ADDENDUM FOUR
Water Treatment Plant
High Service Pump Upgrades
TDEC Project No.: DW20220948
City of Springfield, Tennessee
Bid No. 1250
Griggs & Maloney Project No. 1141-16

To: All Plan Holders
Owner: City of Springfield, Tennessee
Engineer: Griggs & Maloney, Inc.
Project: Water Treatment Plant
High Service Pump Upgrades
File 1141-16
TDEC Project No.: DW20220948

PROJECT NO: 1141-16
 DRAWN BY: AGC
 CHECKED BY: AGC
 APPROVED BY: AGC
 DATE: 08/10/22
 SCALE: AS NOTED
 SHEET NO: E-101

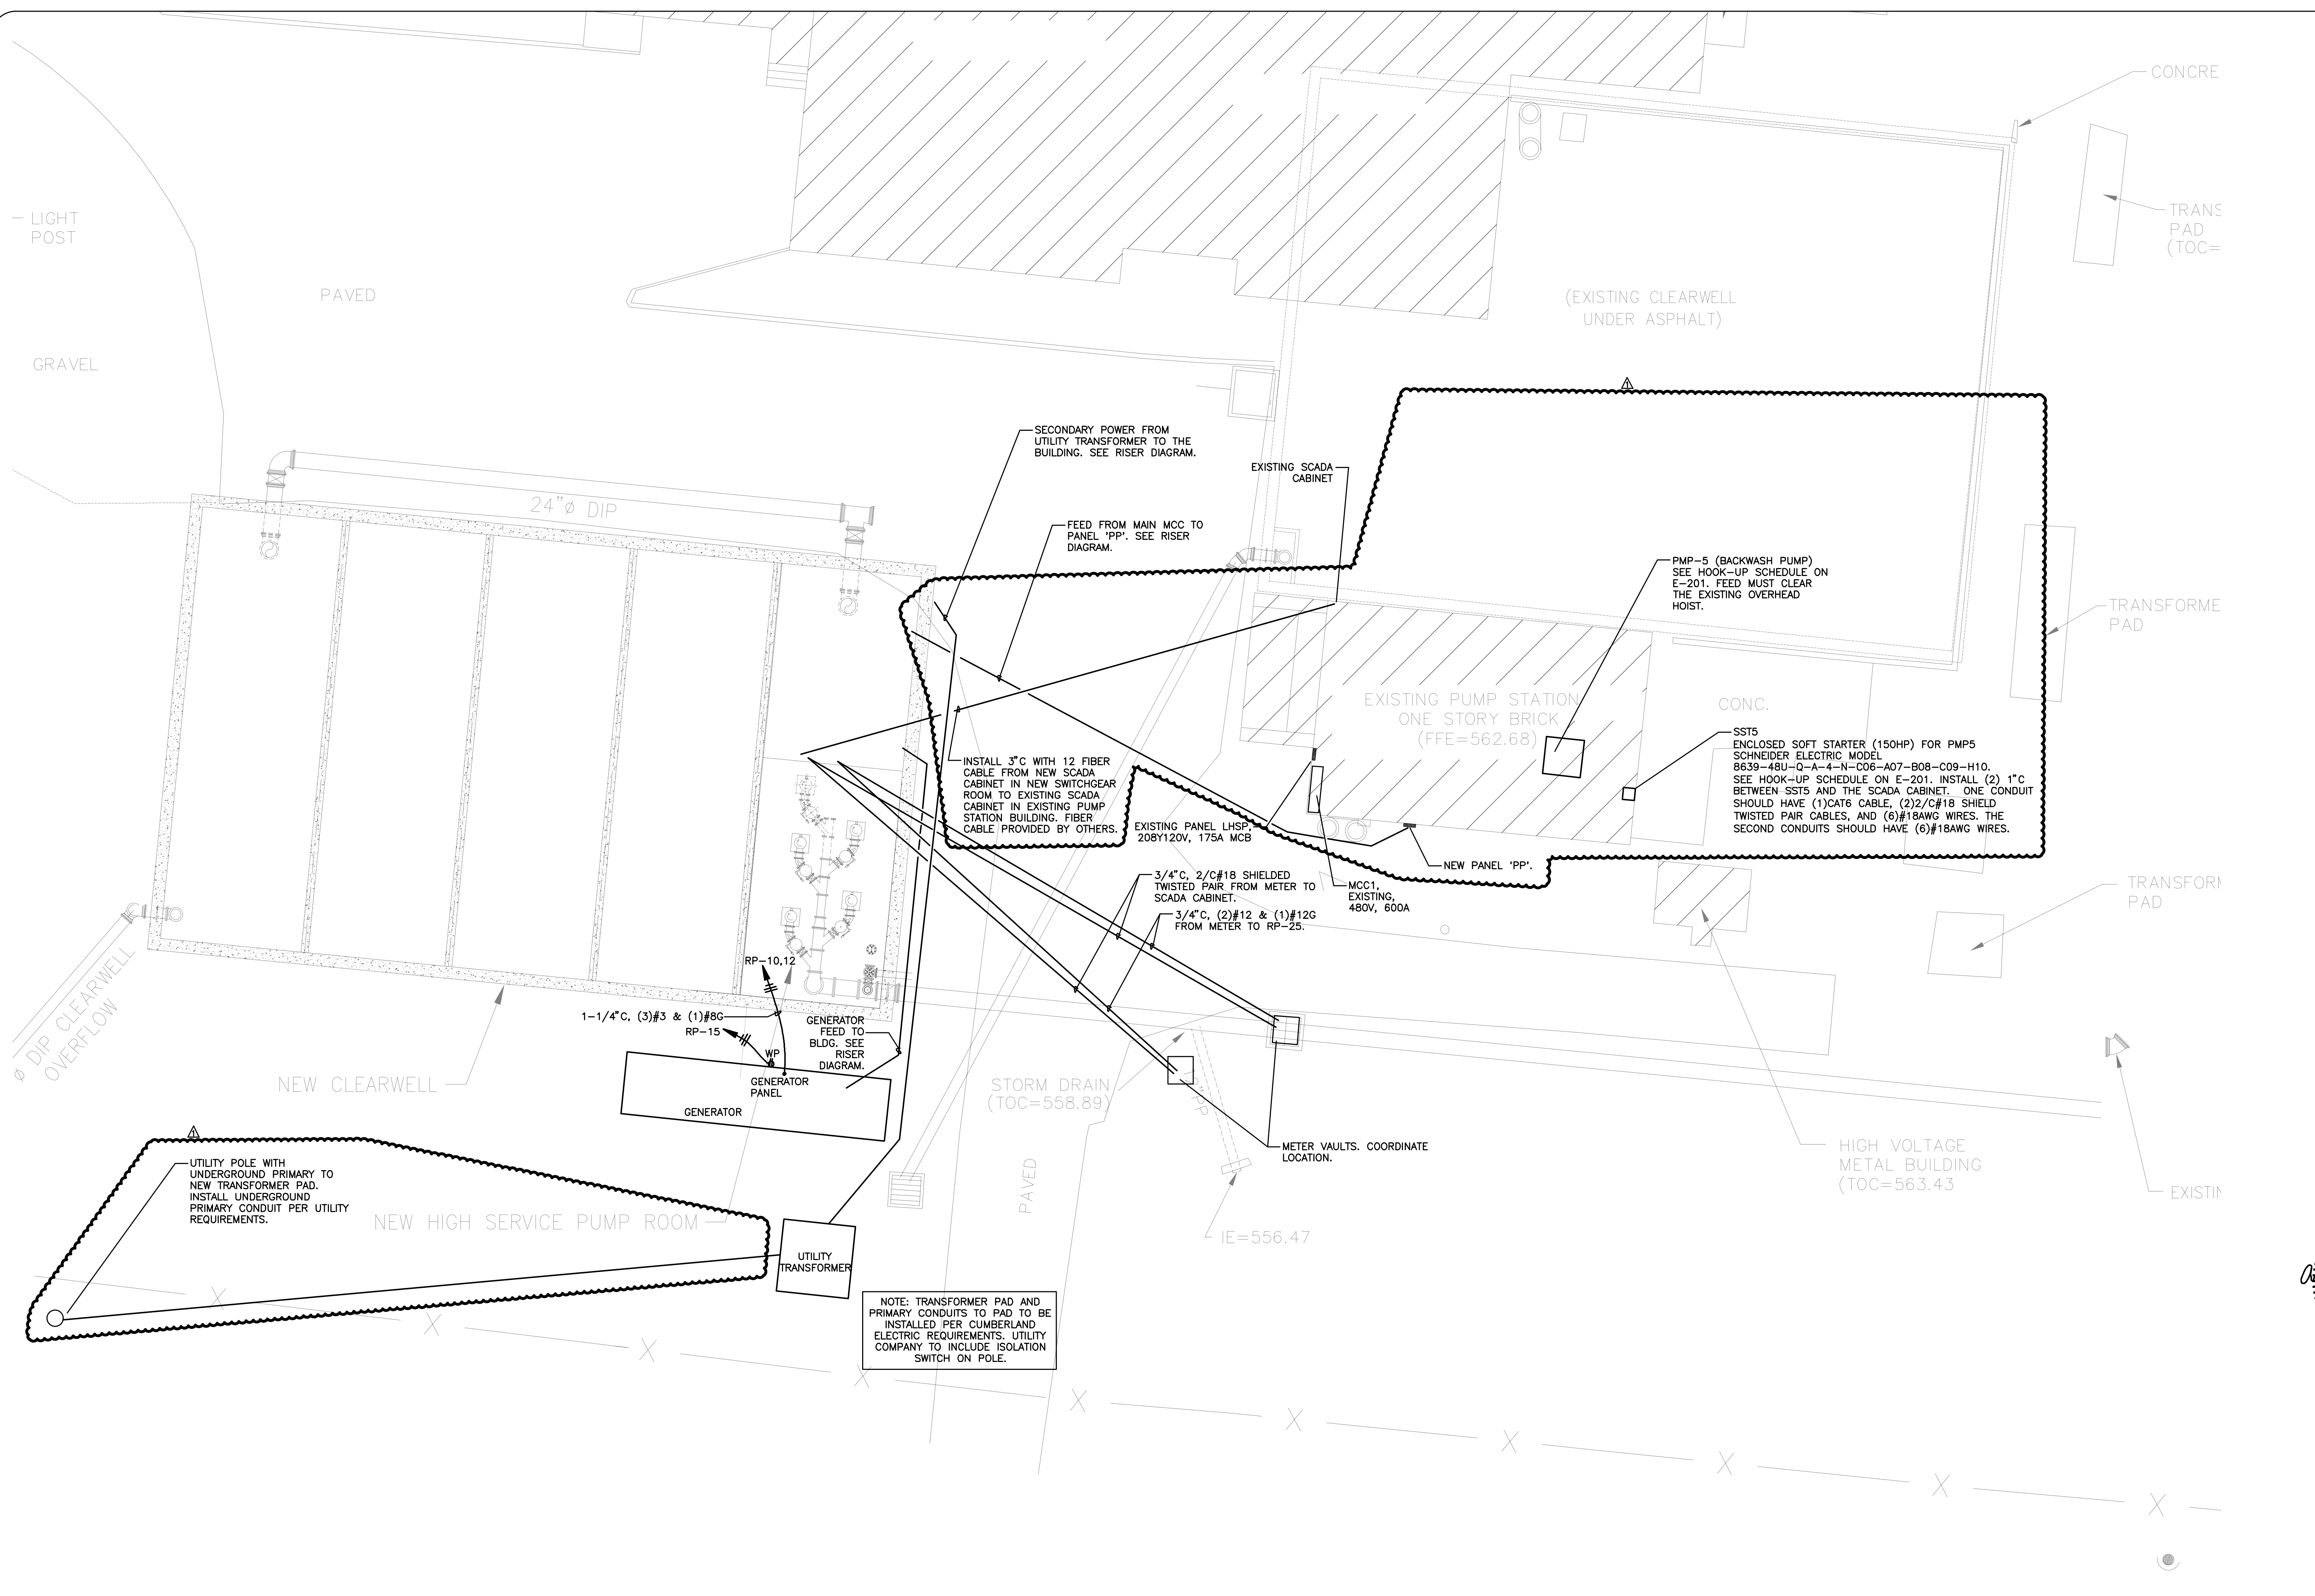
10. **Question:** Sheet E-101 Notes. Who provides/pulls primary wire? **Answer:** The primary wires are provided and installed by the utility. The Contractor is responsible for installing the conduits per the utility requirements.

11. **Question:** Sheet E-101 Notes. Who provides/installs utility transformer? **Answer:** The Contractor installs the transformer pad per the utility requirements. The utility company will provide and install the utility transformer.
